# Service Bulletin SB0042

**Date:** September 2002  
**From:** Capstone Technical Support  
**Subject:** Checking Exhaust Dome Alignment  
Model C30 MicroTurbine

T-bolt and  
Self-locking Nut

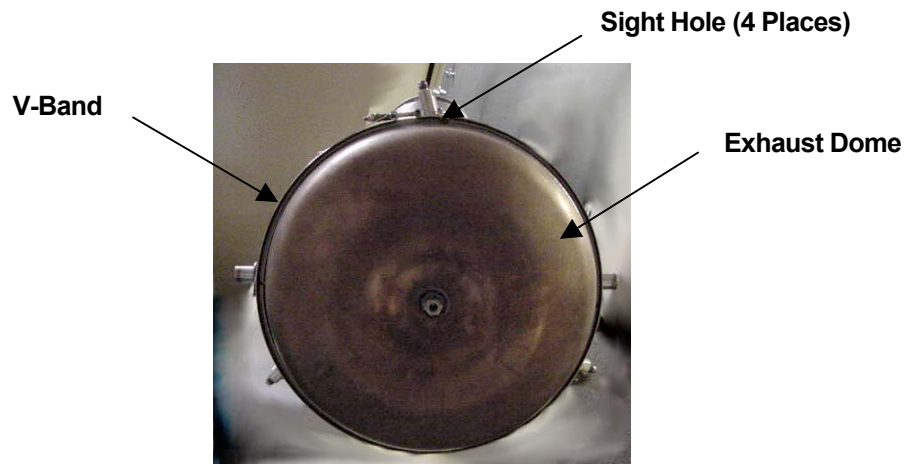
5. Look directly into the four sight holes located around the edges of the exhaust dome under the V-band. If the exhaust dome is aligned properly with the engine, the edges of the exhaust dome and the engine will be flush in all four places.

6. If the exhaust dome is out of alignment, loosen the self-locking nut on the T-bolt sufficiently to allow the exhaust dome to move around.

7. Using a rubber mallet, tap the exhaust dome a little at the edges and then tighten the T-bolt a little at a time, while looking through the sight holes. Repeat this step as required until the exhaust dome is aligned with the engine when looking through the four sight holes.
8. Using a 7/16-inch torque wrench, tighten the self-locking nut to 120 lb-in torque.
9. Slide the thermal blanket into its original position and secure it in place using tie wires.
